寄件者: TsangShun Qi <[REDACTED]>  
寄件日期: 2026年01月12日星期一 11:29  
收件者: Cheryl Tsz Man TSANG/PLAND  
主旨: 回复 : Re: Planning Application No. A/NE-MKT/56 Proposed Temporary Warehouse for Storage of Car Parts and Associated Filling of Land for a Period of 3 Years  
附件: A\_NE\_MKT\_56\_AFCD comments & response.pdf; A\_NE\_MKT\_56\_DSD comments & response-01.pdf  
類別: Internet Email

## Appendix A - Site Photos

寄件者: TsangShun Qi <[REDACTED]>  
寄件日期: 2026年01月13日星期二 13:29  
收件者: Cheryl Tsz Man TSANG/PLAND  
主旨: 回复 : Re: Planning Application No. A/NE-MKT/56 Proposed Temporary Warehouse for  
Storage of Car Parts and Associated Filling of Land for a Period of 3 Years  
附件: A\_NE\_MKT\_56\_Lands comments & response.pdf  
類別: Internet Email

View A (Existing Open Channel )

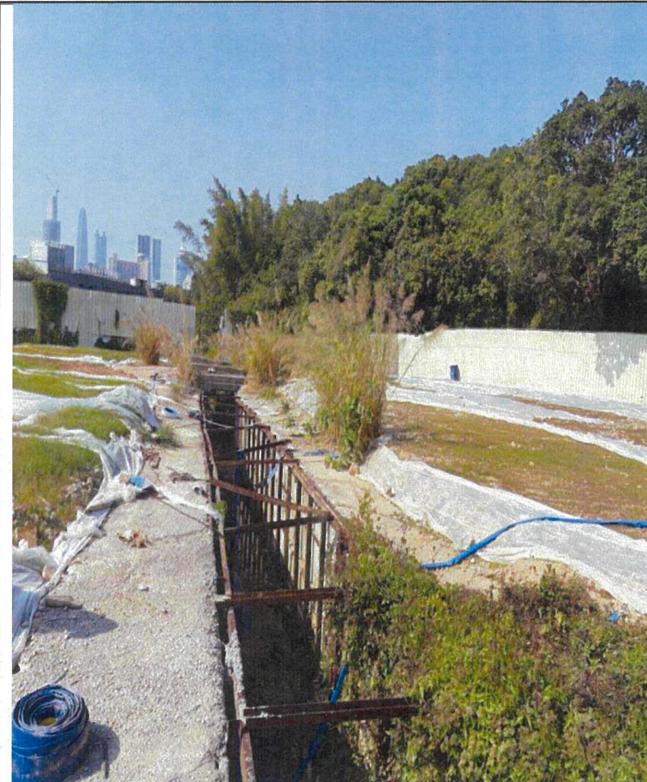
05-01-2026	<p>The applicant should provide more site photos with different viewpoints to confirm whether the whole watercourse within the application site is already modified.</p>	<p>The whole watercourse within the application site be constructed to an existing 2.1m(W) x2.7m(D) open channel.</p> <p>In this S16 application, the applicant has submitted a proposal to the Drainage Services Department to modify the existing open channel into a trapezoidal channel. Construction has not yet commenced.</p> <p>All site photos refer to Appendix A</p>
